Application for Works Approval

Works Approval Number	W6660/2022/1
Applicant	Wiluna Operations Pty Ltd
ACN	166 954 525
File number	DER2022/000021
Premises	Wiluna Mine Site Legal description Within Mining Leases M53/32, M53/96, M53/200, M53/26, M53/40 and M53/50 WILUNA WA 6646 As defined by the premises map attached to the issued works approval
Date of report	17 August 2022
Decision	Works approval granted

Figure 1: Location of SPP (Stage 2) at the Premises

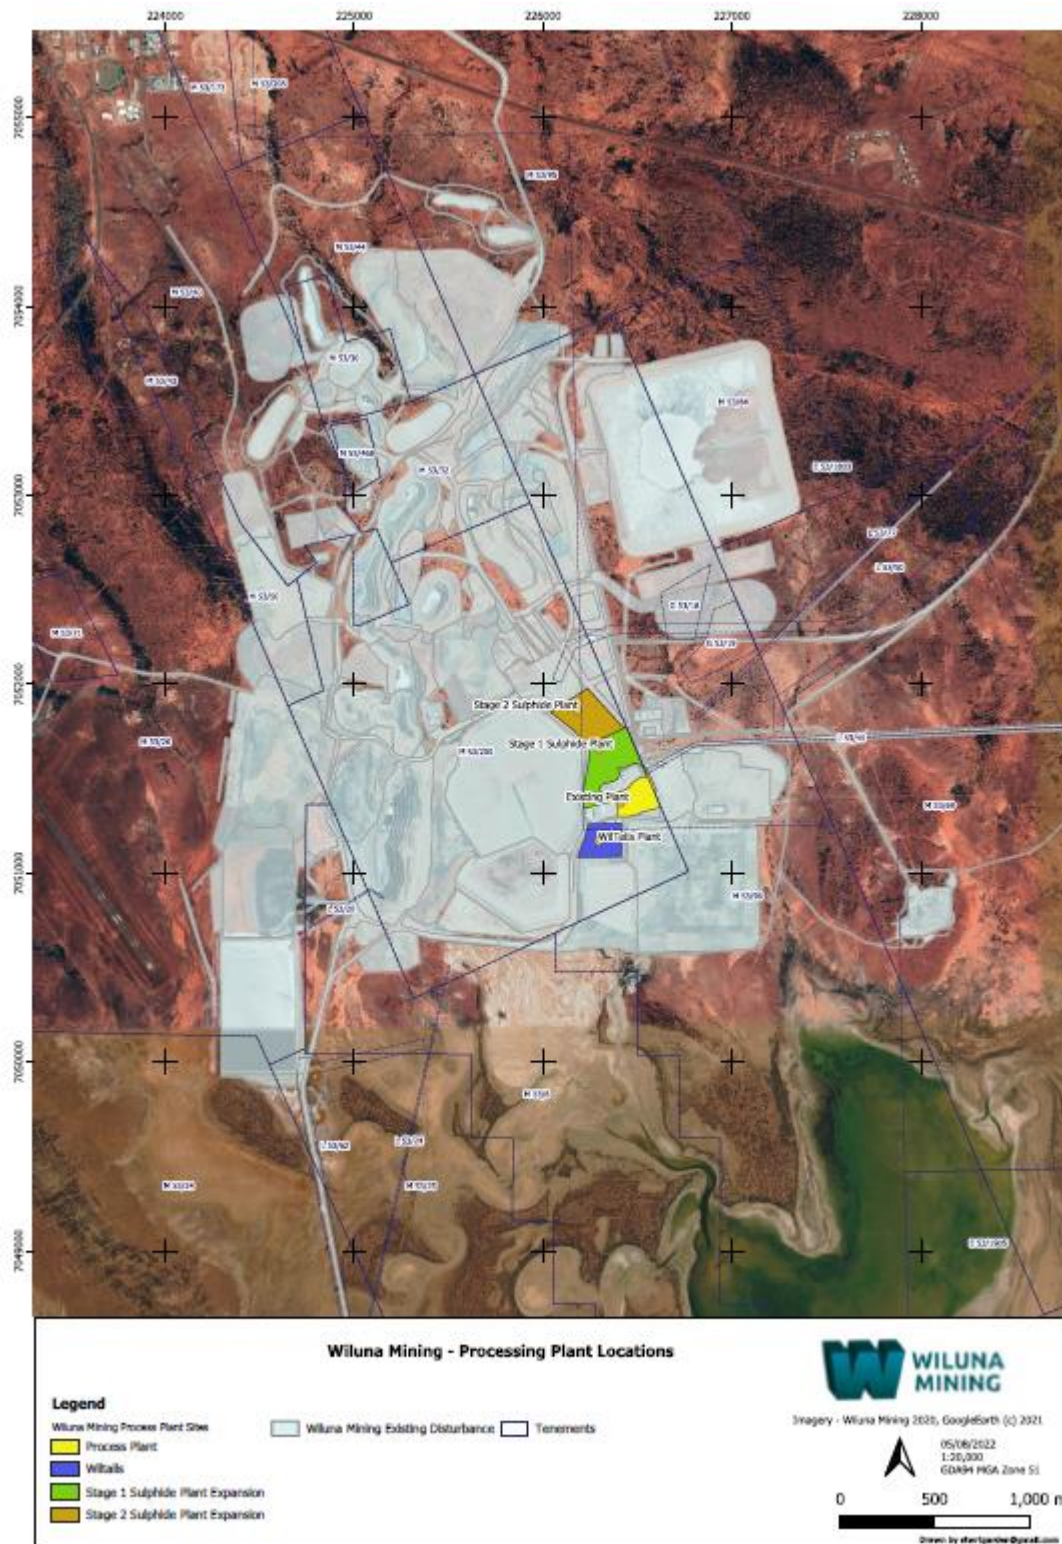
Condition	Summary of applicant's comment	Department's response
infrastructure.		
<p>Figure 3 of Schedule 2: Sulphide Processing Plant (Stage 2) general arrangement</p> <p>DWER requested that the Applicant provide an updated figure with better resolution as the image is blurred when zooming in to view the infrastructure.</p>	<p>The Applicant provided an updated Figure 2 with better resolution as requested.</p>	<p>Updated Figure 3 of Schedule 2 of the Works Approval accordingly.</p>
Decision Report		
<p>Section 2.3.3 of the Decision Report: Geochemistry and geotechnical analysis of sulphide tailings</p> <p>DWER requested the Applicant confirm that the environmental commissioning for the SPP Stage 1 has commenced.</p>	<p>The Applicant confirmed the environmental commissioning has commenced.</p>	<p>Noted.</p>
<p>Figure 1 of the Decision Report: Location of SPP (Stage 2) at the Premises</p> <p>DWER requested the Applicant provide an updated map that clearly shows the SPP for Stages 1 and 2 at the Premises.</p>	<p>The Applicant provided an updated map as requested.</p>	<p>Updated Figure 1 of the Decision Report accordingly.</p>

Figure 2: Containment Infrastructure and Surface Water Management Plan

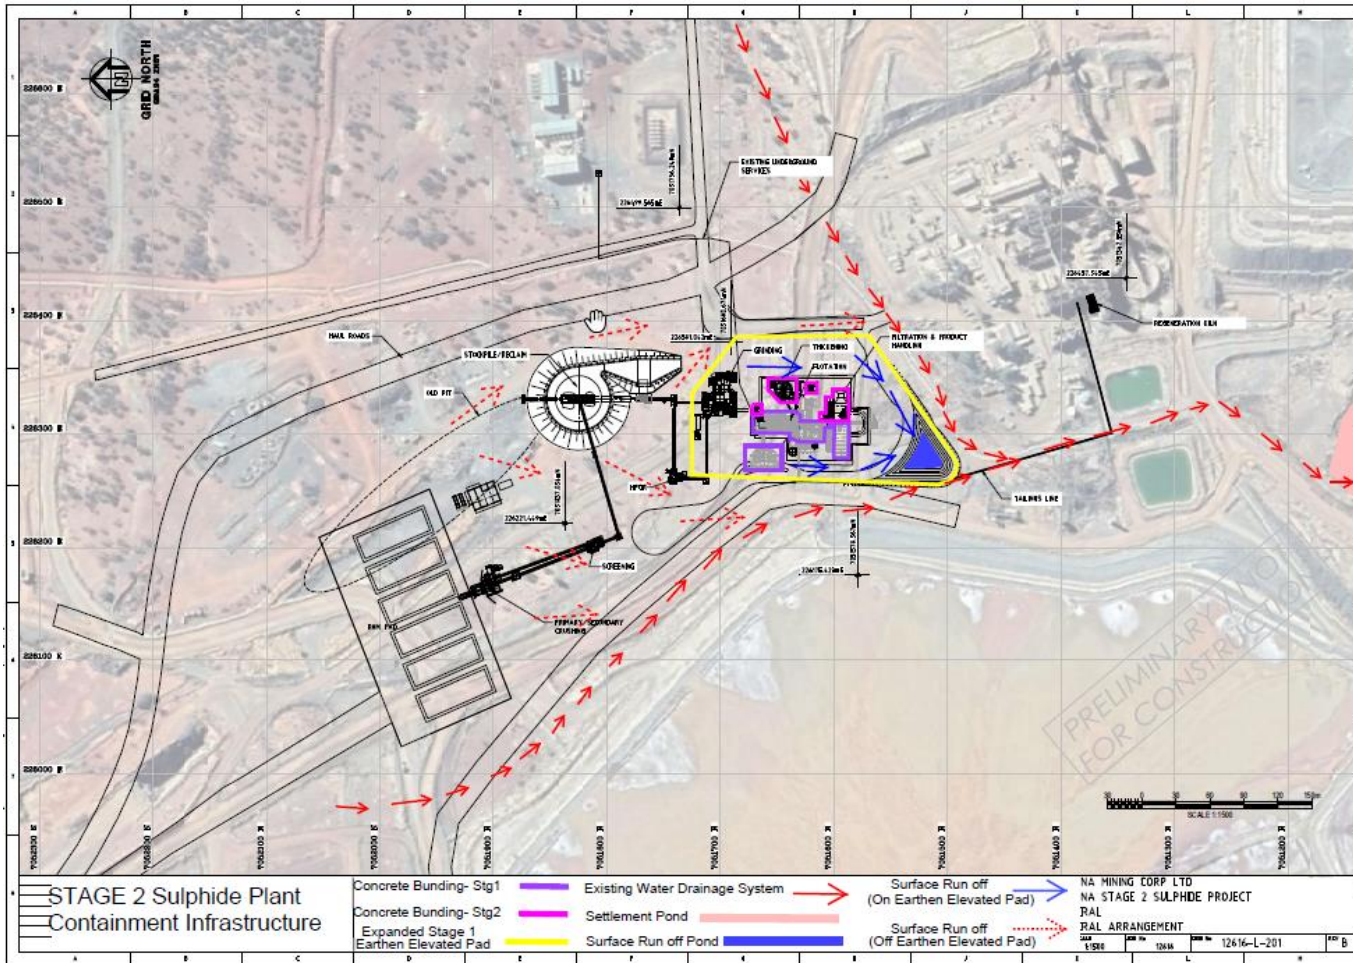
<p>Figure 2 of Schedule 1: Containment Infrastructure and Stormwater Management Infrastructure Map</p> <p>DWER requested that the Applicant provide an updated figure with better resolution as the image is blurred when zooming in to view the</p>	<p>The Applicant provided an updated Figure 2 with better resolution as requested.</p>	<p>Updated Figure 2 of Schedule 1 of the Works Approval accordingly.</p>
